Re: TEEL RESIDENCE Garage / Companion Unit
416 Nautilus Street
Combination Building Permit - Approval No. 2216948, Project No. 621791
Coastal Development Permit, Process Two - Project No. 669815

**COMBINATION BUILDING PERMIT - Approval No. 2216948, Project No. 621791
CURRENT GARAGE CONSTRUCTION NOT IN ACCORDANCE WITH THE REQUIREMENT FOR A CDP**

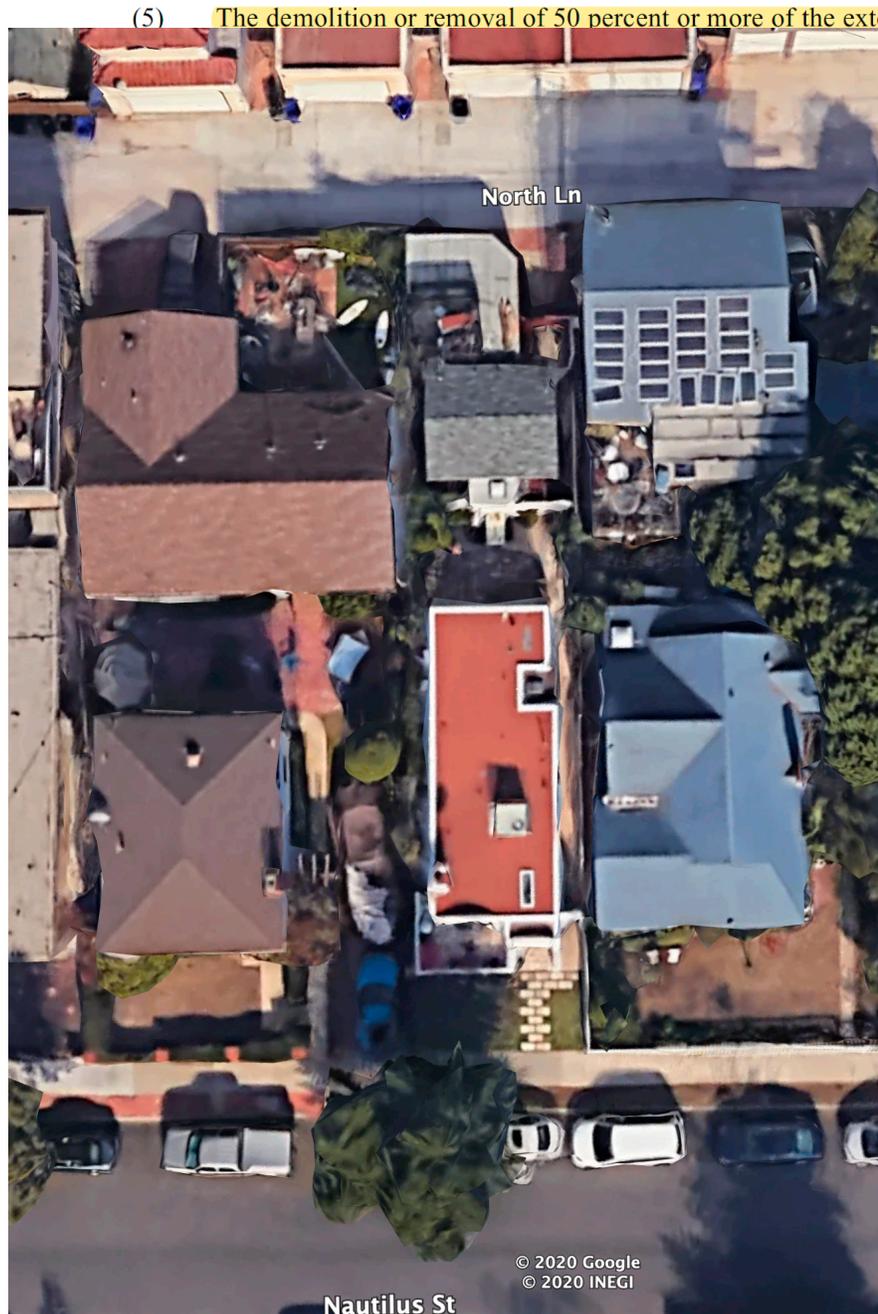
For purposes of orientation the prior garage fronted on the south side of an east-west alley (North Lane) behind 416 Nautilus Street as depicted in the 25 foot wide lot in the center of the following aerial photo. The garage door was on the north exterior wall of the previously existing garage.

But contrary to Section 126.0704(a)(5) the requirement for exemption from CDP review and permitting, more than 75 percent (three of the four) previous garage exterior walls have been completely demolished as can be seen in the photographs on the following pages.

Therefore, in accordance with SDMC Section 126.0704(a)(5), the CDP exemption should be rescinded, all construction activity should be stopped, and the applicant should apply for a Coastal Development Permit before any work is allowed to proceed.
